TECHNICAL EVALUATION REPORT (REVISION 1)
ON THE PROPOSED DESIGN MODIFICATIONS AND
TECHNICAL SPECIFICATION CHANGES ON
GRID VOLTAGE DEGRADATION FOR THE
PEACH BOTTOM ATOMIC POWER STATION
UNITS 2 AND 3

(Docket Nos. 50-277, 50-278)

March 11, 1983

FIGURE 1 PEACH BOTTOM ATOMIC POWER STATION ELECTRICAL ONE-LINE DIAGRAM

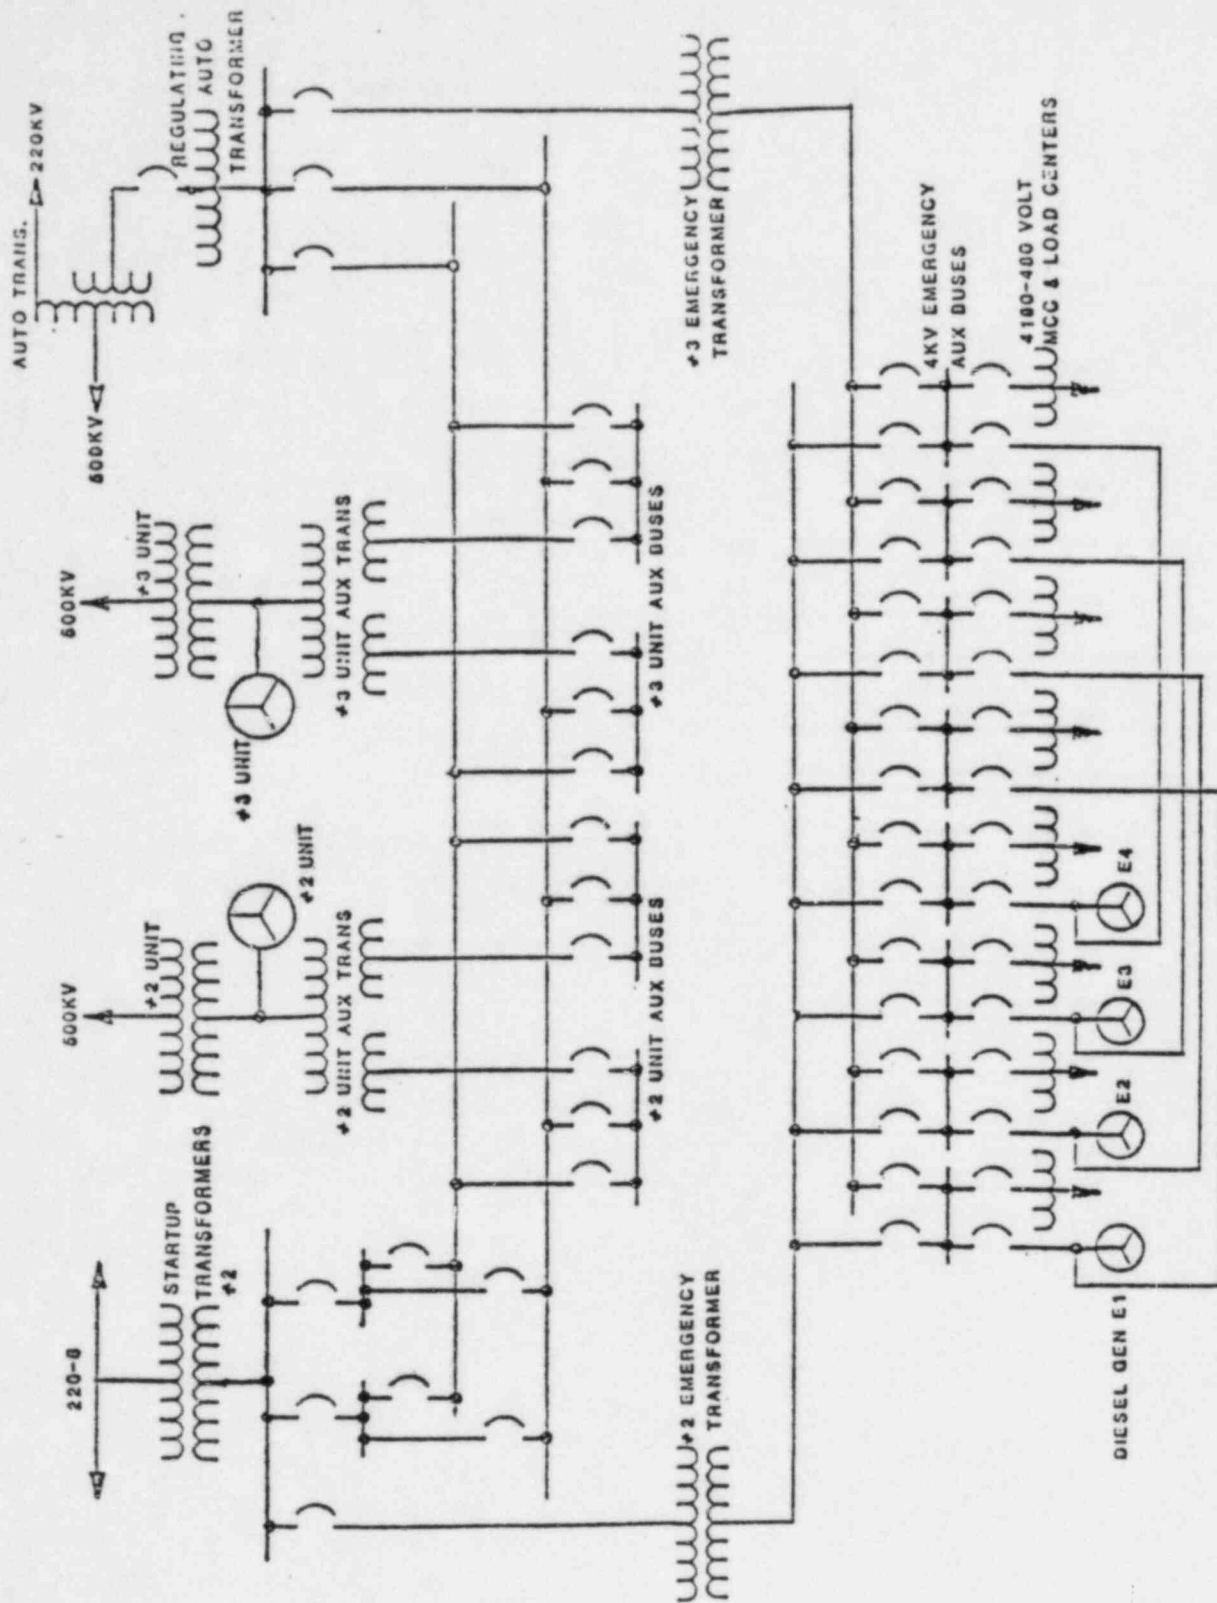
A one-line diagram of Peach Bottom Atomic Power Station's Unit 2 and 3 (Peach Bottom) electrical distribution system is shown in Figure 1. This figure was adapted from Figure 1 of a September 15, 1976, Philadelphia Electric Company letter to the NRC [Ref. 15]. There are eight 4160-volt Class 1E buses. Under normal operating conditions these buses are energized from the offsite power sources through emergency transformers No. 2 and No. 3. Emergency transformer No. 2 is energized by startup transformer No. 2 which is equipped with automatic tap changers. With sustained grid voltage fluctuations, the automatic tap changer will index every 3-5 seconds after an initial 30 second time delay. Emergency transformer No. 3 is energized by a 50 MVA regulating auto transformer. The unit auxiliary buses are normally energized by the main generator. Upon shutdown of the main generator because of an accident or a transient trip, the unit auxiliary buses are automatically transferred to the offsite power sources.

The present design uses three sets of relays to detect a loss of voltage, shed the load, and restore the voltage on each of the eight 4160-volt emergency buses. Each set of relays and its function on a typical emergency bus is as follows:

- (a) Two inverse time-delay voltage relays (type IAV) monitor the voltage on the source side of each of the two breakers feeding a Class 1E bus. These relays are set to operate at $60\% \pm 5\%$ of

of 4160 volts with a time delay of 1.8 seconds at 0 volts. The function of this set of relays is to sense a loss of voltage and trip the source breaker to its respective bus.

- (b) An HGA relay (instantaneous) monitors the voltage on each bus. The relay functions with no appreciable time delay when the voltage falls below $25\% \pm 5\%$ of 4160 volts. The function of this relay is to initiate load shedding and to provide a permissive signal to transfer the bus to the alternate source, or if the alternate source is not available, to start the emergency diesel generator.
- (c) A third relay monitoring the bus voltage is an SV relay. It will actuate at $95\% \pm 0\%$, -10% of 4160 volts. The function of this relay is to initiate load sequencing once the voltage has been restored to the Class 1E bus.
